**Attachment B**

**AFFIDAVIT OF BRADLEY J. HUNSBERGER**

6. In this Affidavit, I specifically respond to the technical items raised by the Board concerning Brickyard Unit I's hydrological characteristics as related to Section 814.402(b)(3)(A), (C) and (F) of the Board's rules (Items 1-4) and the items concerning Brickyard's interpretation and calculation of the "average annual high water mark" as related to Section 814.402(b)(3)(H). (Item 10). Further, I concur with the assessments presented in the Amended Petition as related to the Board's questions concerning Brickyard's intended long-term maintenance of the proposed cover plan (Items 5-9).

ILLUSTRATION 1

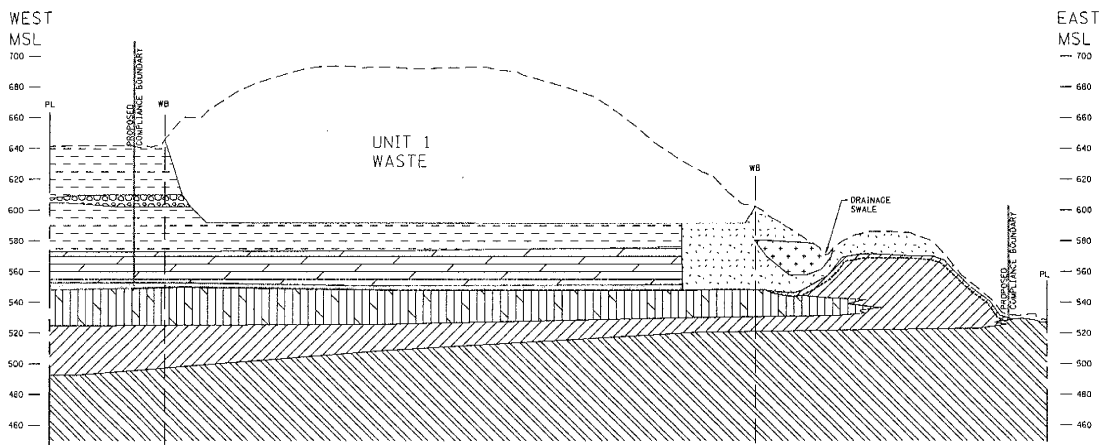
15. The bottom of the uppermost aquifer is the upper part of the Middle Shale and the Sandy Siltstone deposits. See Illustration #1, attached hereto.

18. Therefore, the bottom of the uppermost aquifer is the top of the Middle Shale (from the west end to the area under the extraneous materials) and the top of the Sandy Siltstone (east of the extraneous materials area). The actual transition of the Middle Shale to the Sandy Siltstone at the bedrock surface will vary with location. Both of these geologic formations serve as the bottom of the uppermost aquifer.
